## **Access Compliance Report Public Rights-of-Way** (Curb Ramps)

Intersection ID: 27742 Main Street: BREM LN **Cross Street: OLD WAYSIDE RD** Location: NW

ADA ID: 77BBD9887E8E Ramp Type: BlendTrans1 Initial Pass/Fail: Fail **Overall Compliance: No** Severity Score: 33.75

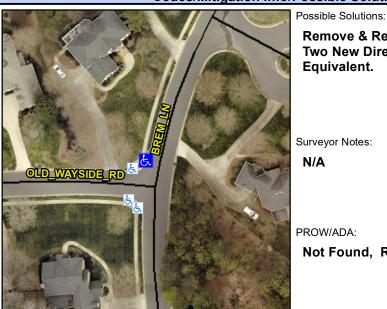
Not Found, R304.5.1, R304.5.3

Field Measurements/Component Compliance						
Compliance Description		Data	Compliance Description		Data	
N/A	Ramp Length (in)	47.0	Yes	BlendTrans Slope (%)	3.9	
No	Ramp Width (in)	43.0	No	BlendTrans XSlope (%)	8.7	
N/A	Flare Type LT	N/A	N/A	Flare Type RT	N/A	
N/A	Flare Slope LT (%)	N/A	N/A	Flare Slope RT (%)	N/A	
N/A	Flare Traversable LT?	N/A	N/A	Flare Traversable RT?	N/A	
N/A	Landing Length (in)	N/A	N/A	DWS Provided?	N/A	
N/A	Landing Width (in)	N/A	N/A	DWS Contrast?	N/A	
N/A	Landing Slope (%)	N/A	N/A	DWS Length (in)	N/A	
N/A	Landing X Slope (%)	N/A	N/A	DWS Full Width?	N/A	
N/A	Landing Curb? (Y/N)	N/A	N/A	DWS Offset (in)	N/A	
N/A	Shared Landing?	N/A				
N/A	Gutter Ponding?	N/A	N/A	Gutter Slope (%)	N/A	
N/A	Gutter Lip Ht (in)	N/A	N/A	Gutter X Slope (%)	N/A	
N/A	Painted X Walk1?	No	N/A	Painted X Walk2?	N/A	
	X Walk 1 Direction	To E		X Walk 2 Direction	N/A	
	X Walk 1 Width (in)	N/A		X Walk 2 Width (in)	N/A	
	X Walk 1 Slope (%)	2.5		X Walk 2 Slope (%)	N/A

X Walk 1 X Slope (%)	7.0		X Walk 2 X Slope (%)	N/A	
N/A	Ramp inside XWalk1?	N/A	N/A	Ramp inside XWalk2?	N/A	
	Road Slope (%)	7.0		Clear Space?	N/A	
	Road X Slope (%)	2.5	N/A	Clear Space to XWalk (in)	N/A	
N/A	Any Obstructions?	N/A	N/A	Storm Grate/Utility Hazard?	N/A	
	Obstruction Type			Storm Grate/Utility Type		
		N/A			N/A	
			Yes	Surface Condition? (G/P)	Good	
			No	Curb Slope (%)	8.4

Street 1 Name Stop Condition-Street 1 Street 2 Name Stop Condition-Street 2 **Remove & Replace Curb Ramp With Two New Directional Ramps or** Equivalent.
